ISSUE: Permit to Demolish/Capsulate (partial), Certificate of Appropriateness for alterations and an addition, and a Waiver of the Rooftop Mechanical Screening Requirement

APPLICANT: David Osterndorf and Jennie Korth

LOCATION: Old and Historic Alexandria District
405 South Fairfax Street

BAR #2019-00042 & BAR #2019-00043
405 South Fairfax Street

Figure 1: Areas of proposed demolition

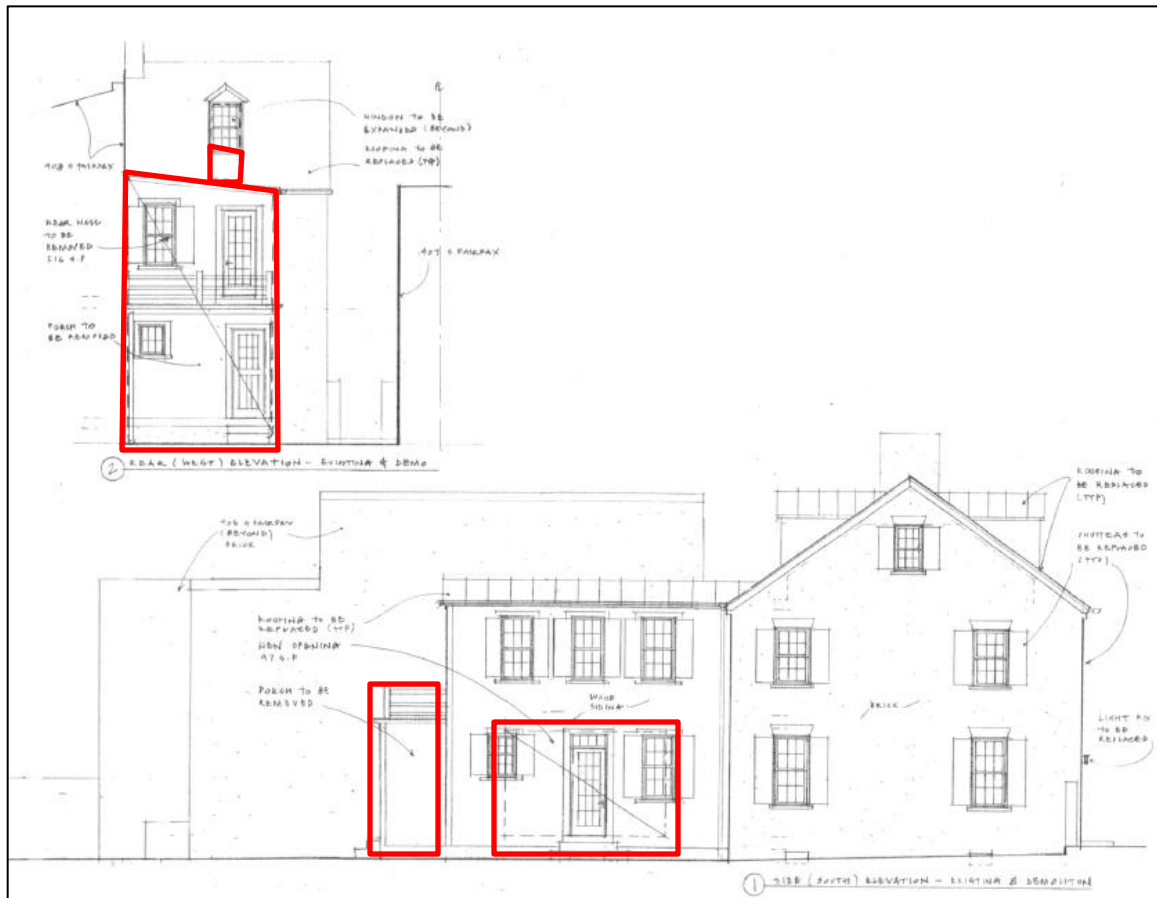
The following features will be demolished to make way for the new construction and alterations (Figure 1):

- Demolish the area under the existing dormer window on the rear roof slope (4.5 square feet)
- Demolish a 13 foot by 8 foot portion of the first-floor south wall of the two-story frame ell (97 linear square feet)
- Demolish the one-story rear frame addition (72 square feet)
- Demolish the second-floor rear elevation of the ell (216 linear square feet)

The applicant's request for demolition and capsulation is not unusual in the Old and Historic Alexandria District, as homeowners seek to create additional modern living space. BAR staff - and the Board - have generally supported such requests if the new construction is sensitively attached and when only a limited amount of historic material is demolished or capsulated. As described in the zoning ordinance criteria, the specific amount depends on the importance of the structure and the material and craftsmanship being demolished or capsulated. In this case, a mid-20th century enclosed porch and portions of the second period frame ell will be demolished.

The amount of demolition on the historic main block is limited to a 2 foot by 2.25-foot area of the rear roof slope, which is not visible from a public way and on its own would not require approval of a Permit to Demolish. On the frame ell an area measuring approximately 100 linear feet, including two windows and a door, will be demolished as will the mid-20th century one story addition and balcony railing and the second floor rear wall. Only a small portion of the existing frame features are visible from South Fairfax Street (Figure 7). Staff has visited the site on more than one occasion to view interior trim and exposed framing to confirm the construction chronology. While the interior framing materials confirm the early 20th construction of the ell, the exterior siding and windows suggest later alterations. The applicant originally suggested the full demolition of the rear ell but worked with staff to find a solution that preserved most of the south façade and the form and framing of the second period, early 20th century ell.

None of the features that will be demolished exhibit a high level of design or architectural detail and they could be reproduced easily. Staff does not find that the proposed demolition compromises the overall integrity of this historic townhouse nor will the demolition negatively impact nearby buildings of historic merit. In the opinion of Staff, none of the criteria are met and the Permit to Demolish for this limited amount of material should be granted.

Figure 8: Visibility of deck railing and addition from the right-of-way

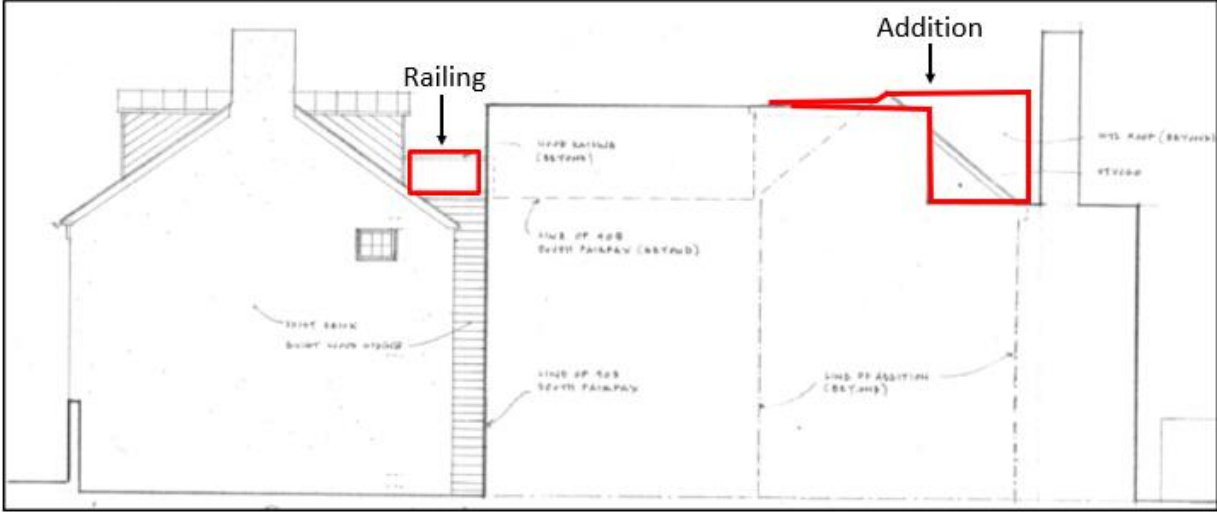
The BAR regularly approves rear additions that are visible from a public way, which is why the *Guidelines* encourage new features to be contextual, compatible and of quality design, while being subtly differentiated from the historic portions. In the opinion of staff, the applicant has achieved this differentiation through the use of different fenestration (two-over-two windows), materials (stucco) and roof form. The addition is also located on a different plane than the historic building or ell – it projects farther into the side yard but will be set back three feet from the adjacent house and fence, though technically six feet from the lot line (three feet of the neighbor's house and garden are located on the lot belonging to 405 South Fairfax Street). The addition in its entirety will not be visible from a public way. Only a small portion of the east elevation of the new addition will be visible from the 5.5-foot walkway between 405 and 407 South Fairfax Street. The railing of the roof deck and a portion of the third floor of the addition will also be visible from the right-of-way, as shown in Figure 8. The railing will only be seen at an oblique angle due to the house on the corner of Wolfe and South Fairfax Street. A portion of the top floor of the addition will be visible from Wolfe Street as shown in the photo in Figure 9.

While staff would prefer a more diminutive addition that does not utilize an attic floor, the applicant strongly desires this additional space and access to a new roof deck. With existing large additions to the north and south of the rear yard, shown in photos the application materials, staff believes the proposed addition will have minimal impact on its immediate neighbors. In comparison to many mid-block additions that the BAR approves, the proposed addition is among the least visible from the right-of-way and staff is in support. As the image below shows (Figure 10), the block where 405 South Fairfax Street is located is quite dense with a variety of building footprints equal to and larger in size. As discussed by the BAR at the previous meeting the context of an addition is more important than its absolute size.

Figure 710: Aerial of subject block showing proposed addition footprint

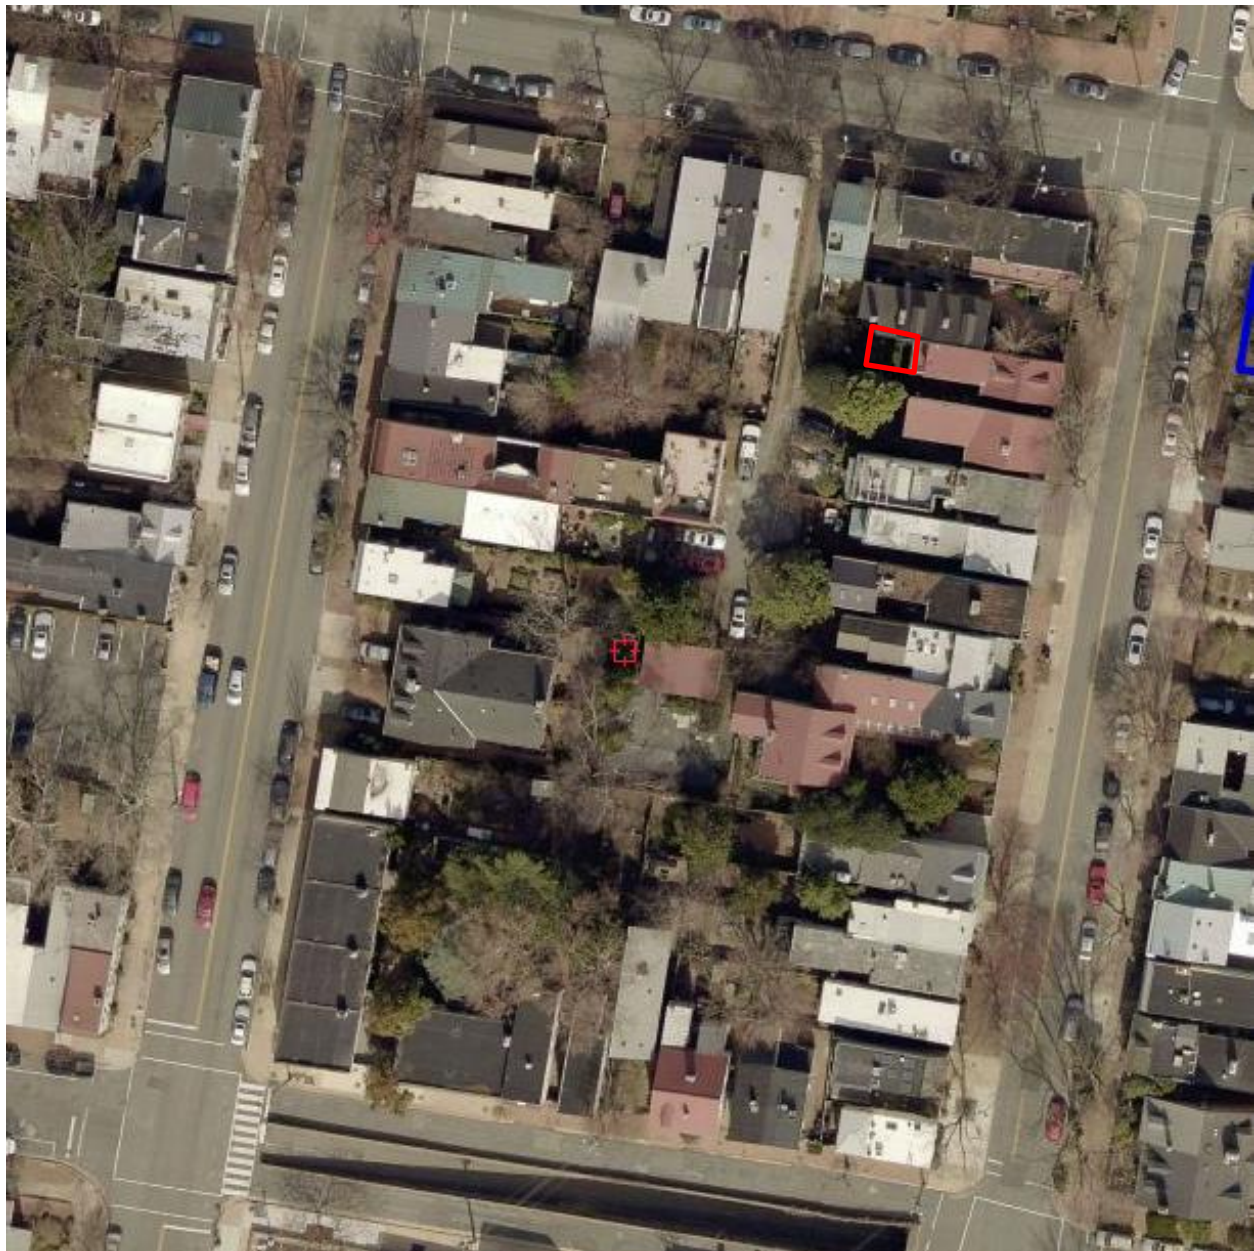
Despite its size, the proposed addition has very little impact on the historic fabric or the original house or additions constructed during the architectural period of significance of the OHAD (1749-1934). It is well designed and compatible with the historic main block yet subtly differentiated in design to suggest its later construction. Although the applicant specifies traditional building materials such as wood, stucco and metal, in recent years the BAR has supported the use of modern and synthetic materials on new construction and staff would have no objection to the use of modern materials in this location that otherwise comply with the BAR's policies.

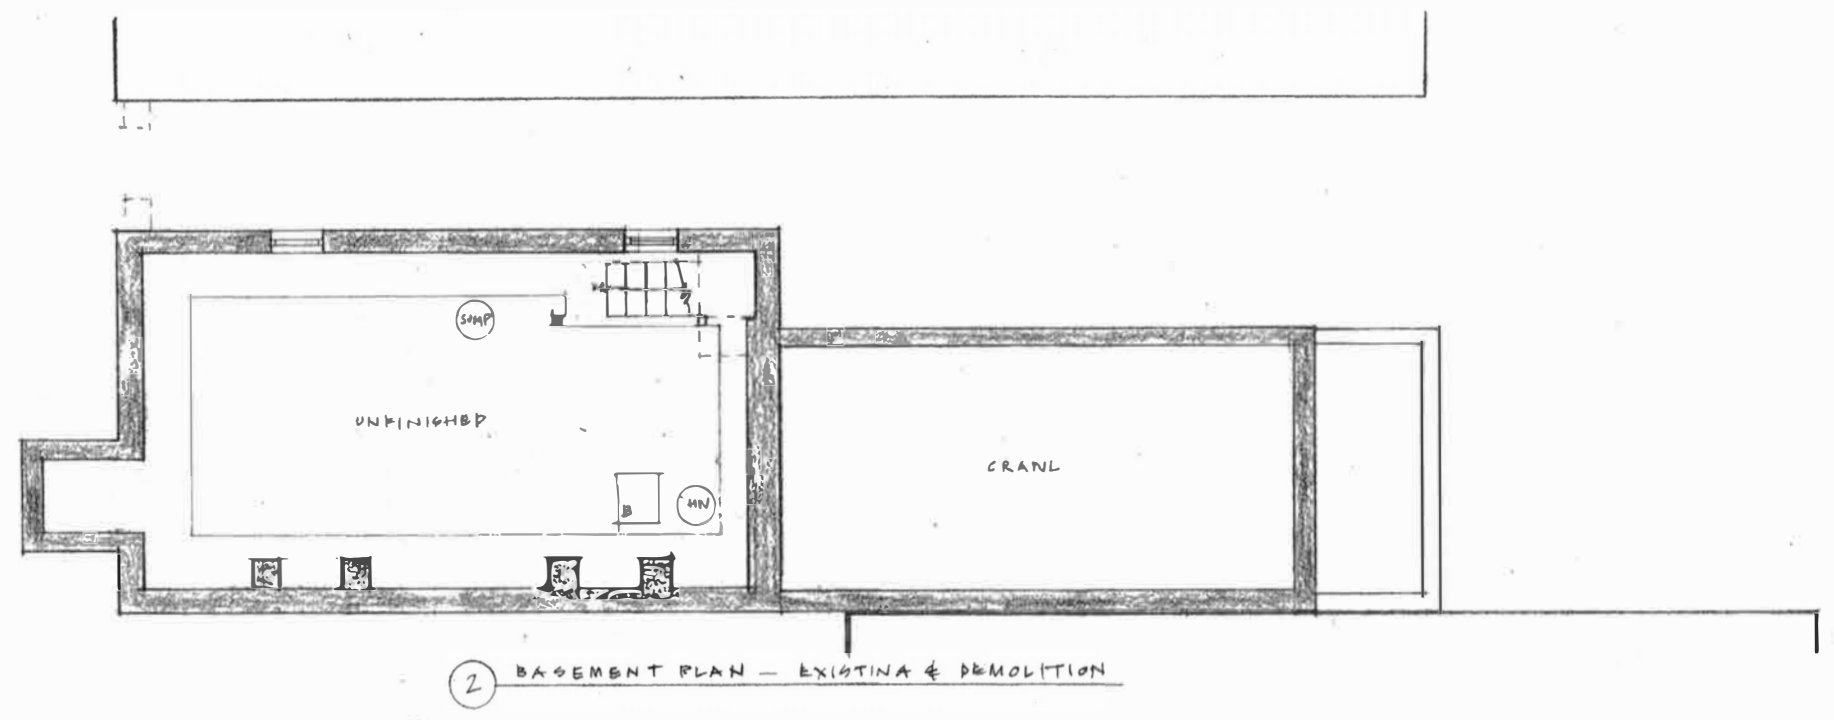
- F-1 Correct "total open space" indicated on submitted plat. Should read 824, not 624. (plans have been updated)
- F-2 Property will maintain the required 5' setback from the south side property line.
- F-3 Proposed roof top equipment will comply with zoning if waiver of screening is approved.
- C-1 Proposed addition will comply with zoning.
